SUBJECT: Transmittal of Amendment 3 to Conventional Explosives Safety Submission (ESS)
McClellan

Amendment 03

Explosives Safety Submission (Conventional)

MEC Remediation at McClellan

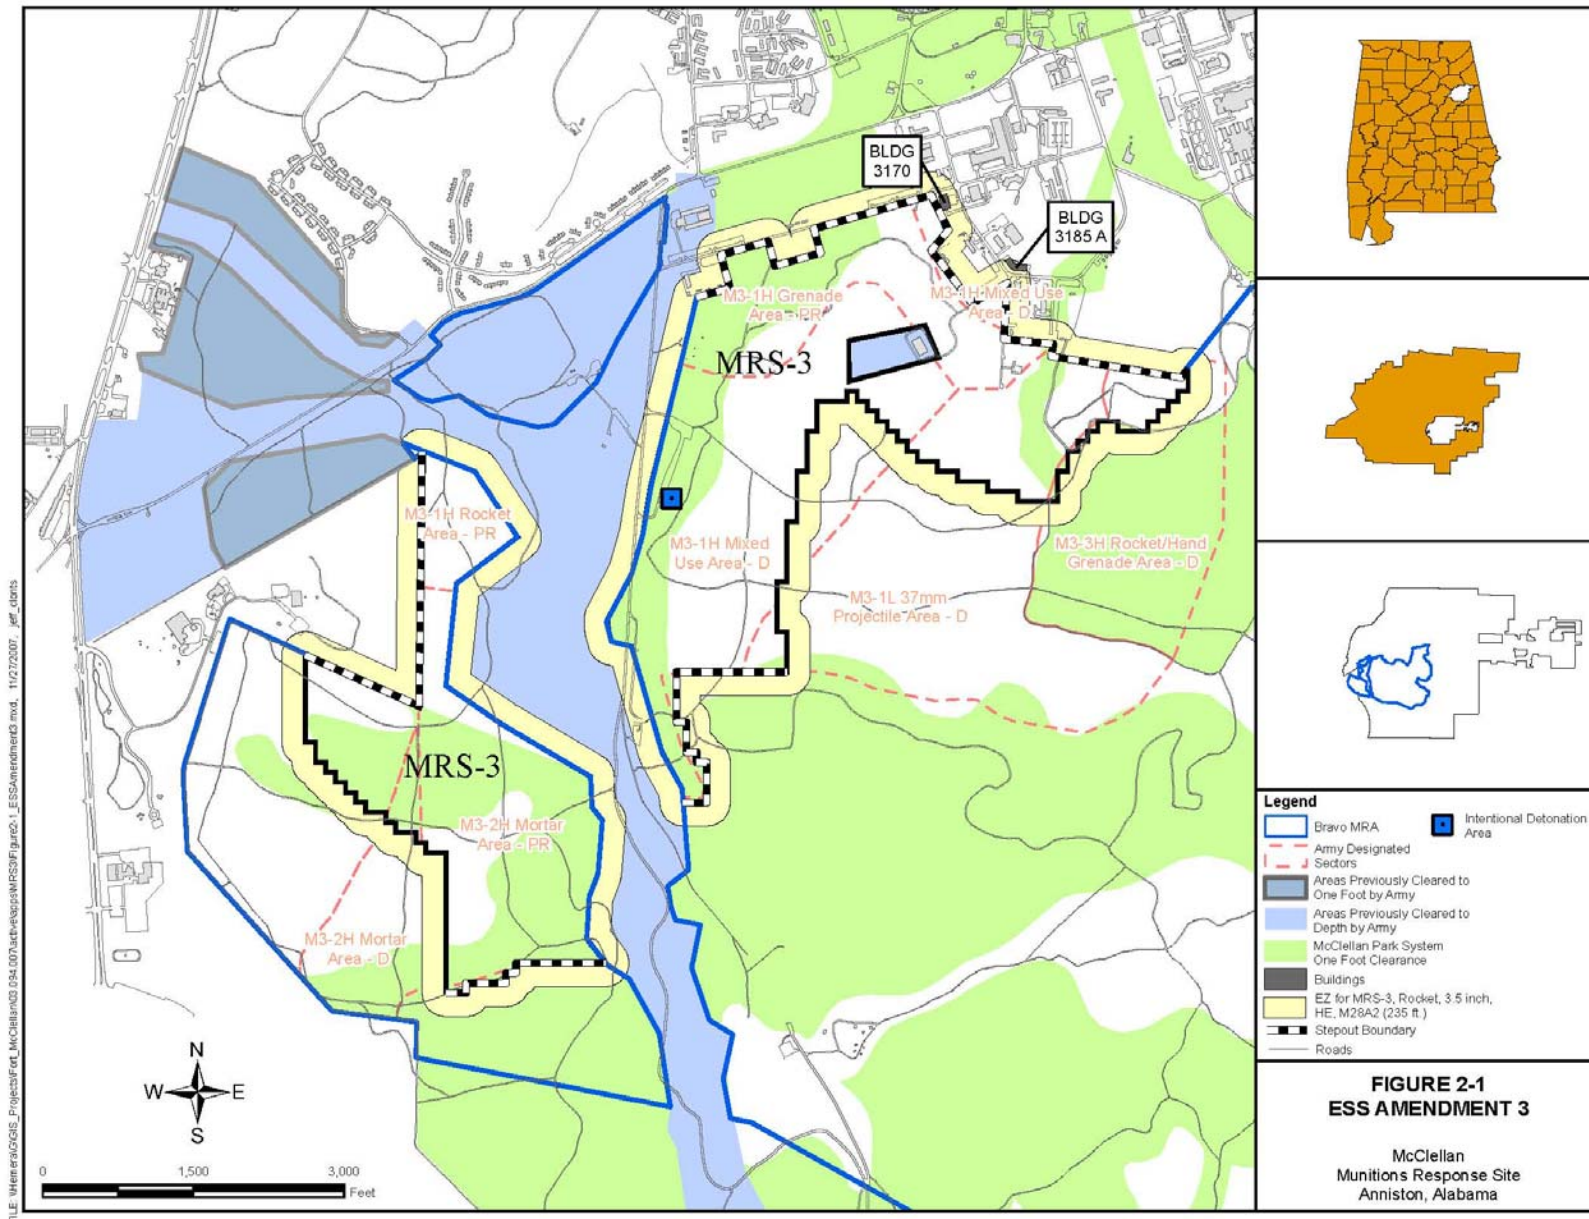
The Fragmentation Data Review Form for the Rocket, 3.5inch, HE, M28A2 is provided in Table 2-1. The MGFD and corresponding exclusion zone (EZ) distance for MRS-3 is shown on Figure 2-1. The EZ is 235 feet and represents the intentional Quantity-Distance (Q-D) Arc based on the HFD of the Rocket, 3.5inch, HE, M28A2.

There are two inhabited building present within the EZ and are noted on Figure 2-1. Building 3170 is used by Jackson State University and Building 3185A is used by Auburn University Canine Detection Training Center. MEC removal activities in MRS-3 will be coordinated and scheduled when these buildings are not in use.

There is no change in the step-out procedures from the approved ESS. The step-out areas are shown in Figure 2-1.

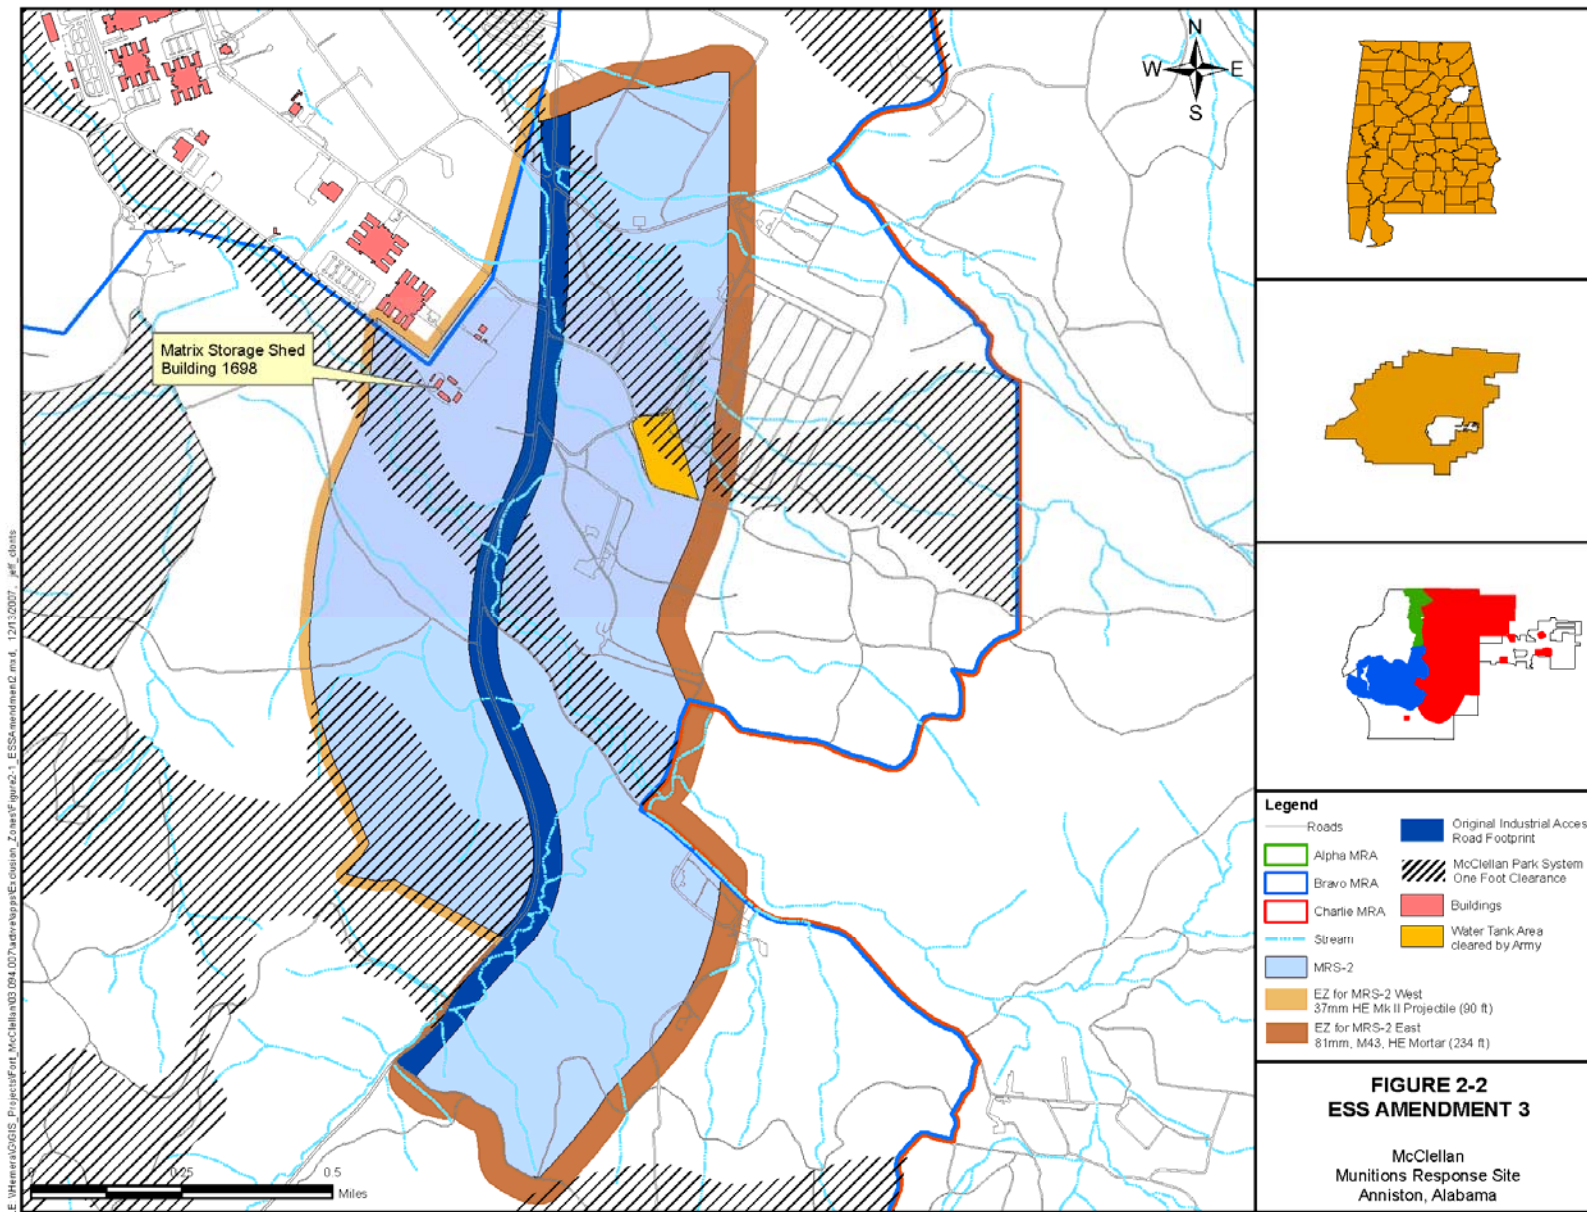
Remediation of MRS-2 is currently ongoing. During the surface sweep a Projectile, 75mm HE, M48 was encountered in MRS-2 east of the Industrial Access Road. A Mortar, 81mm HE, M43 was used to base the original EZ on this portion of the site using the maximum fragmentation distance of 1395 feet. Based on the foregoing Hazard Assessment, we are requesting that the EZ be modified to 234 ft for this area based on the HFD for the Projectile, 75mm HE, M48. The Projectile, 37mm HE, MK II was used to base the original EZ west of the Industrial Access Road using the maximum fragmentation distance of 980 feet. We are requesting the EZ be modified to 90 feet for this area based on the HFD for the Projectile, 37mm HE, MK II. Figure 2-2 is a revised Q-D map for MRS-2 and supersedes Figure 2-1 included in the approved Amendment 2 to the ESS.

Only one inhabited building is present within the EZ's and it is also noted on Figure 2-2. This building is used occasionally by Matrix Environmental Services, LLC; therefore coordination on when the building is being used will not be an issue during MEC operations in MRS-2.
